1. Discussion and Possible Action on Recommendation for Construction Plans for Danamere Farms – Plat 8

RE: **Danamere Farms Plat 8 – Construction Plan Review**
Carlisle, Iowa
FOX Ref No: 8666-03C.258

FOX Engineering has completed the second review for of the Danamere Farms Plat 8 Construction Plans, dated June 11, 2020 and offer the following comments:

DANAMERE FARMS PLAT 8 CONSTRUCTION DRAWINGS

GENERAL
 LAYOUT AND
 DIMENSION PLAN

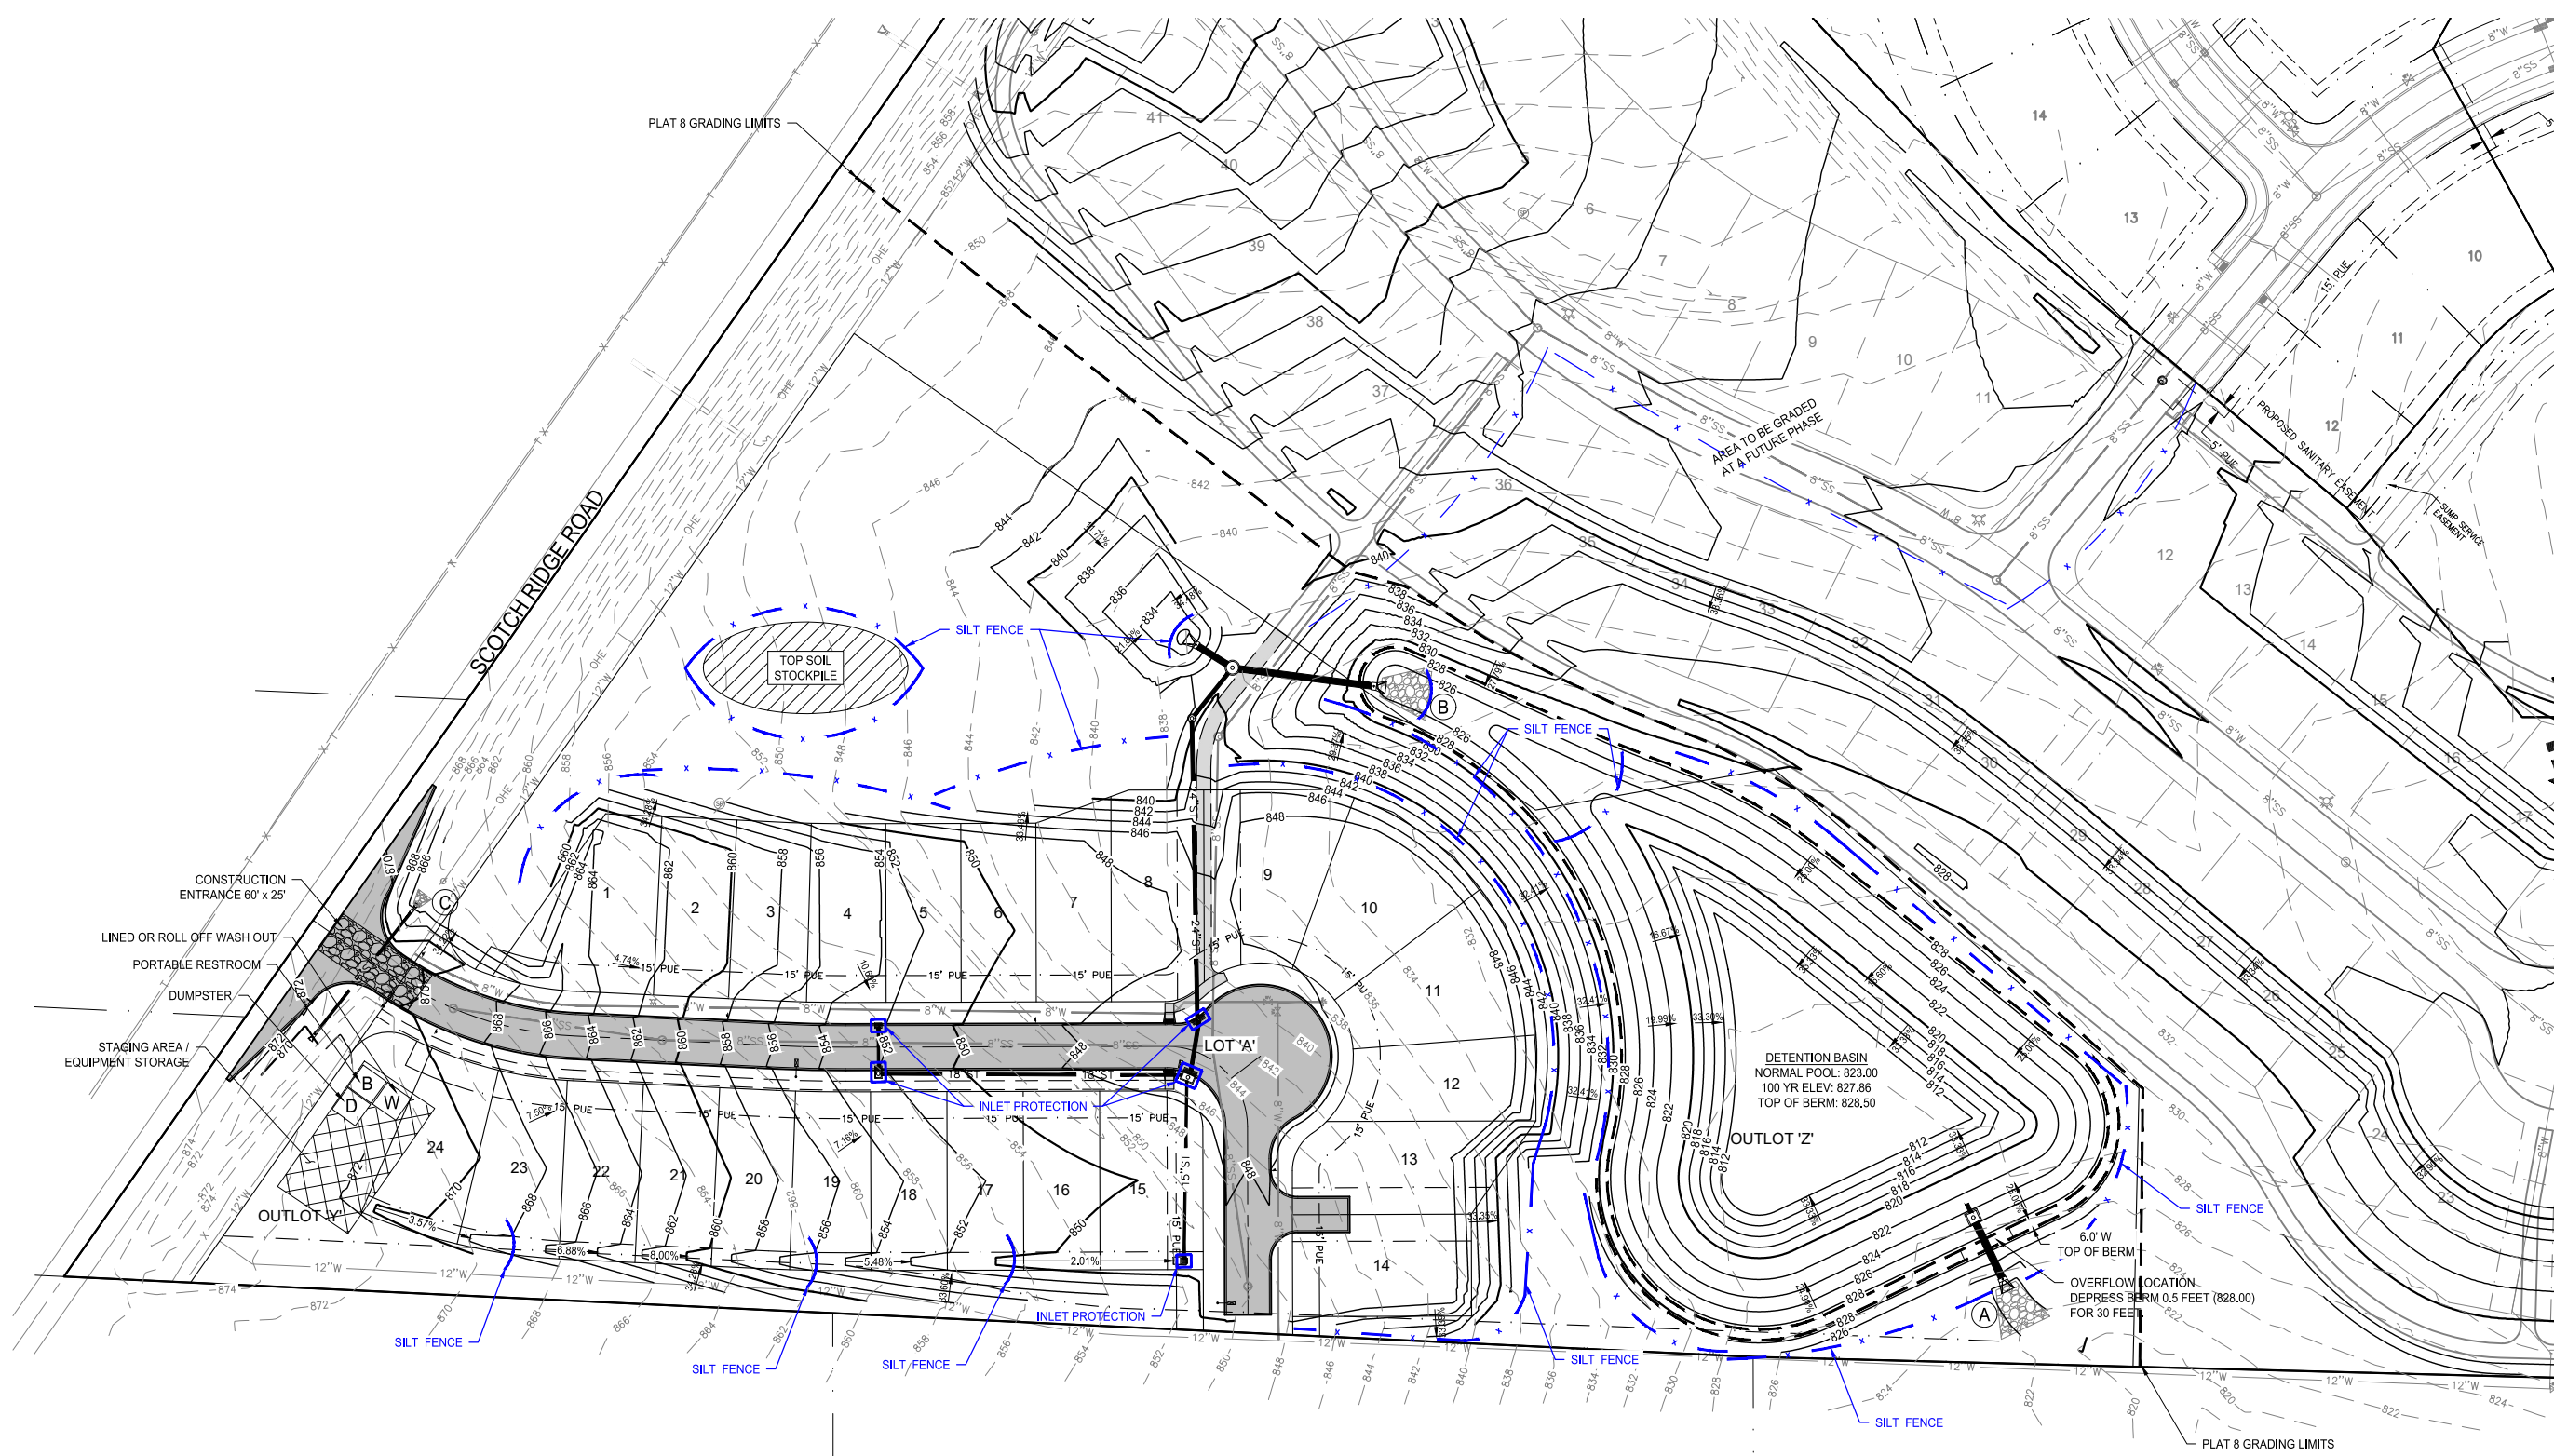
Sheet 4 – General Layout and Dimension Plan

6. Please clarify where the mailbox cluster will be located. It is understood that this will be added once the postmaster confirms the appropriate location.

GRADING PLAN

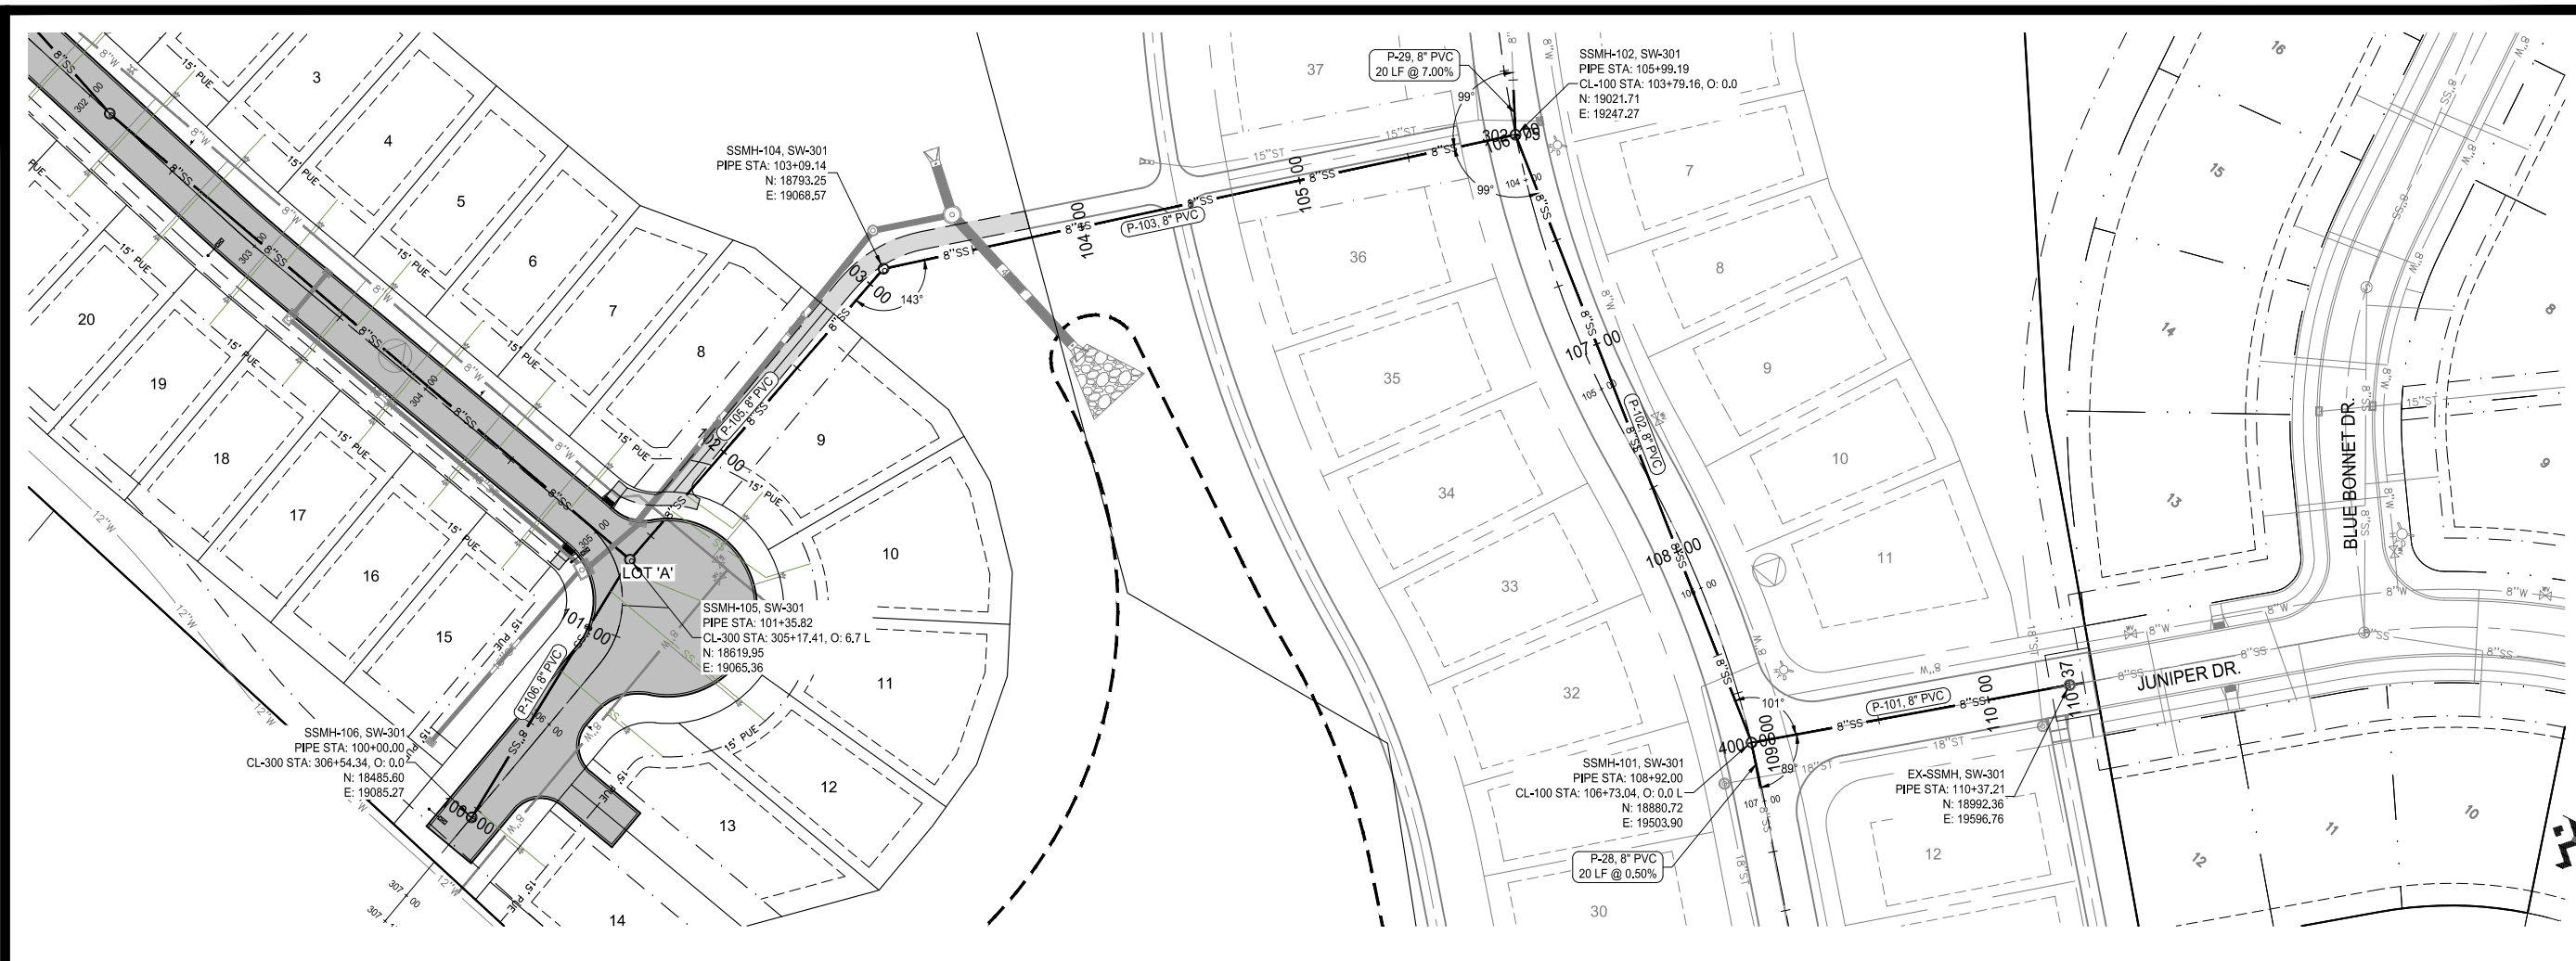
Sheet 6 – Grading Plan

7. Please provide a detail (on this sheet or the detail sheet) that shows the typical detention area grading. It appears the detention area will have a safety bench and different grading typical slopes above/below the bench.
8. It is expected that sanitary sewer work off Juniper Drive will be limited. If contractor intends to use this access for an extended period of time then a construction entrance (aggregate) needs to be installed.

**SANITARY SEWER
 PLAN AND PROFILE**

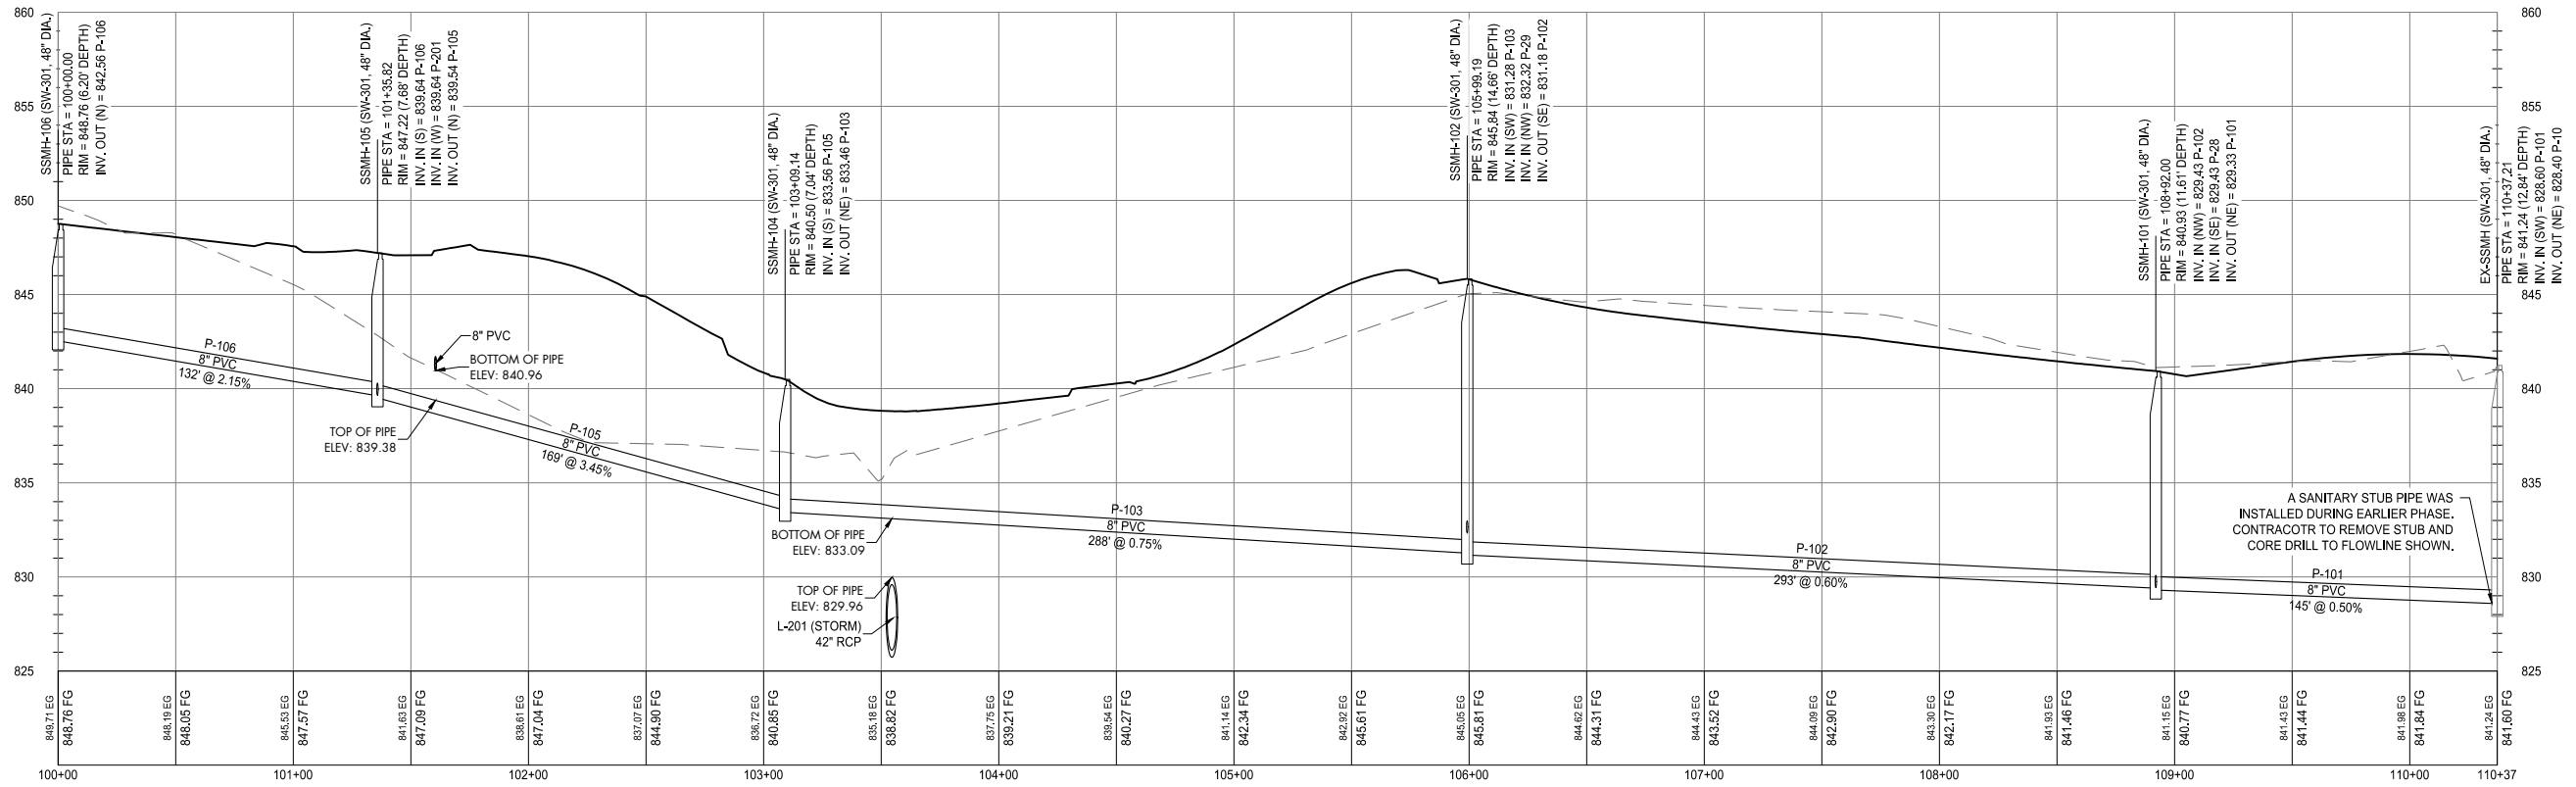
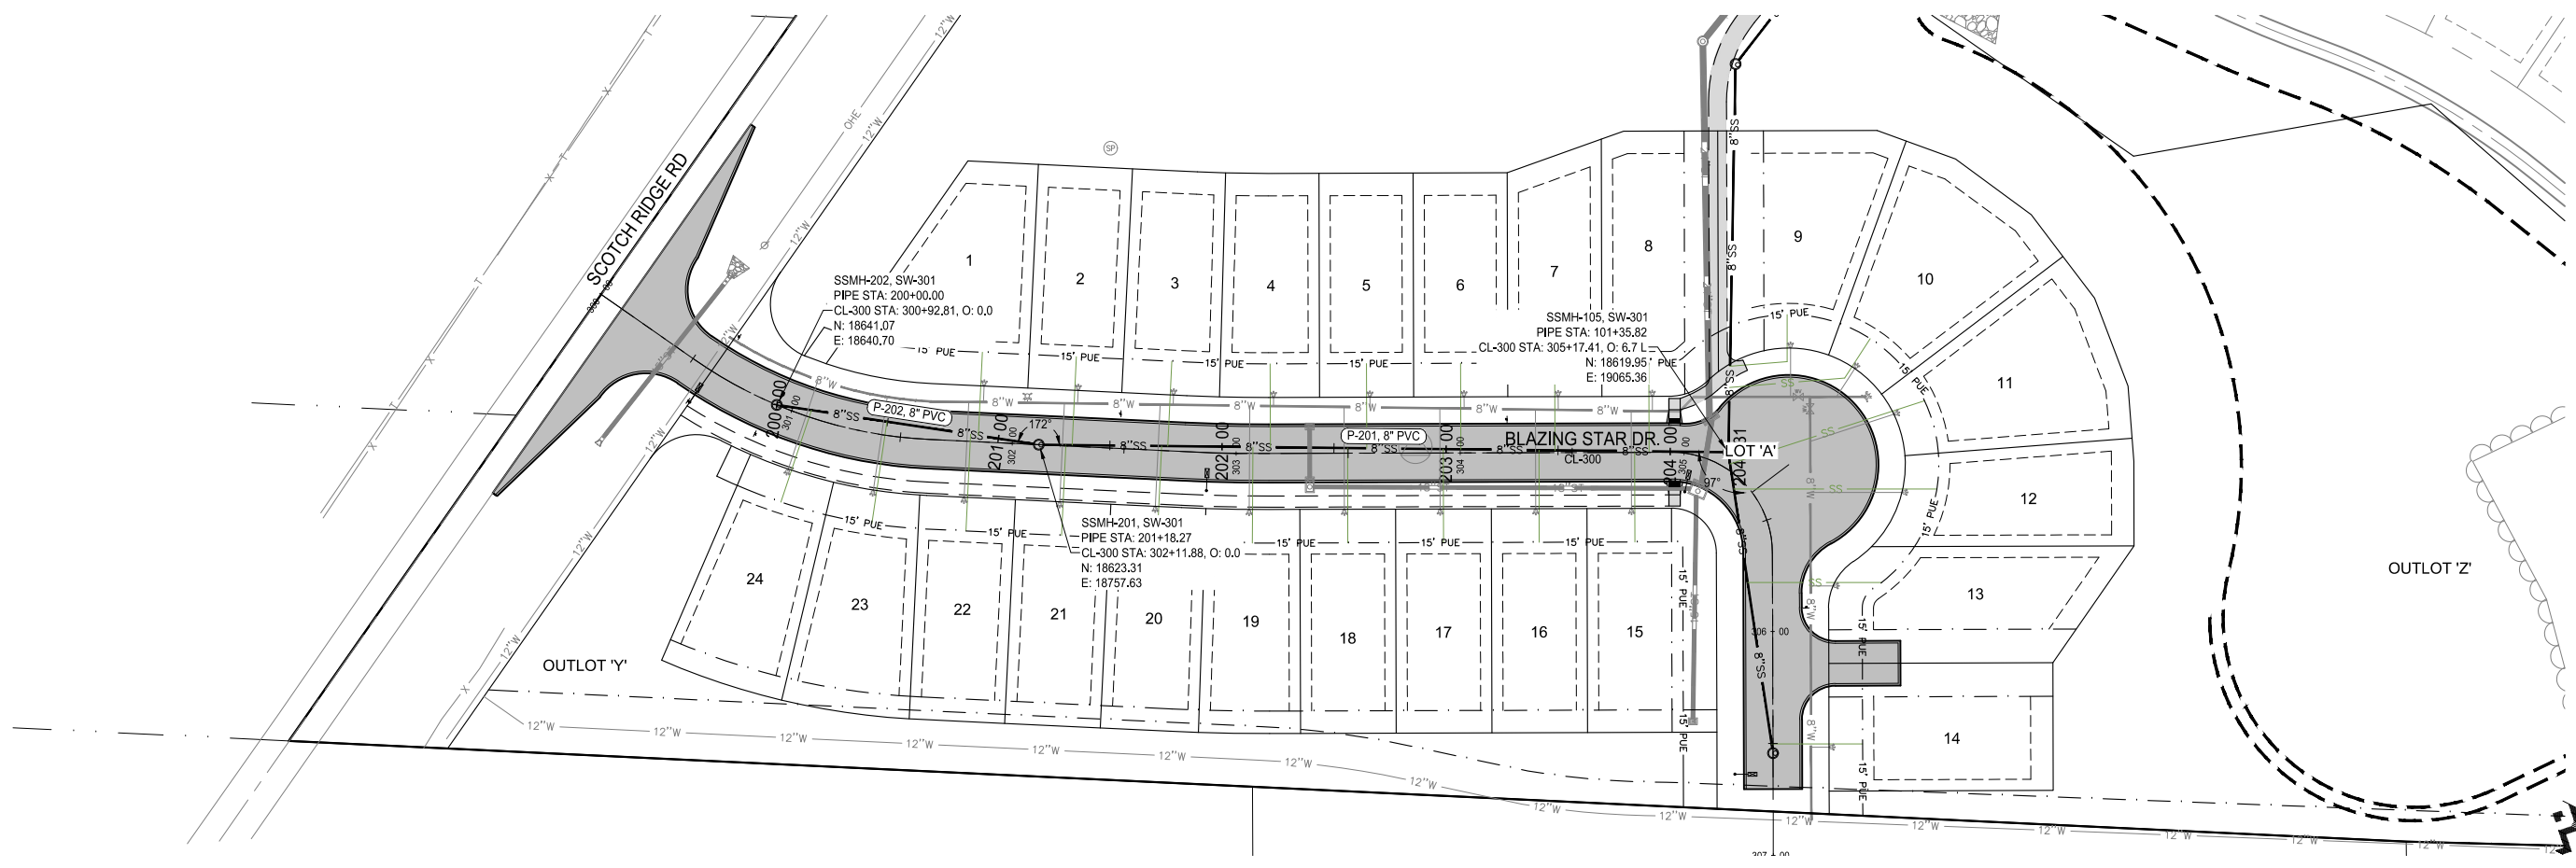
Sheet 6 – Sanitary Sewer Plan and Profile

9. You state that the connection requires removal of the stub and core drilling the flowline. What would the core drilling be for if the stub is already provided? Please revise the plan as necessary.
